## Product Change Notification / SYST-30JOVN709

ERRATA - LAN8670/1/2 10BASE-T1S Ethernet PHY Transceiver Silicon Errata and Data Sheet Clarifications

## Silicon Errata and Data Sheet Clarifications

## d4. Module: Figure 4-4. Crystal Oscillator Input

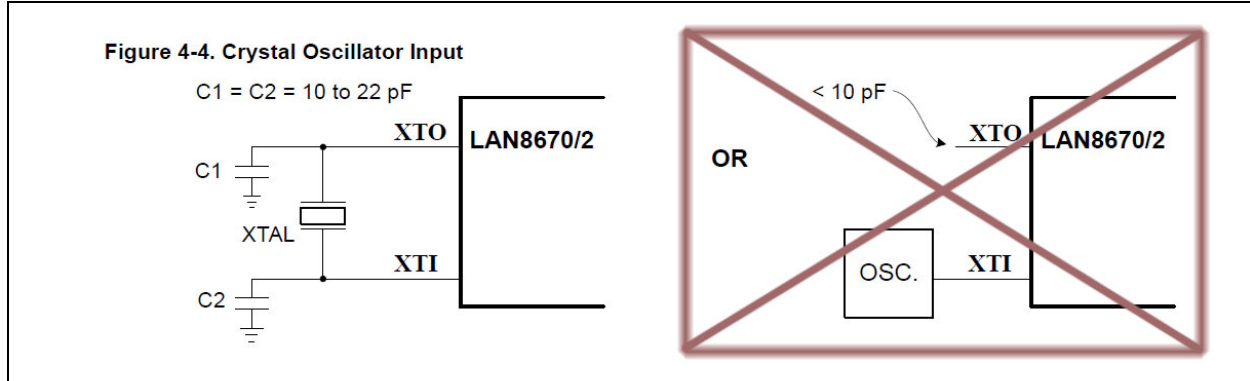
Updates to drawing as shown below:
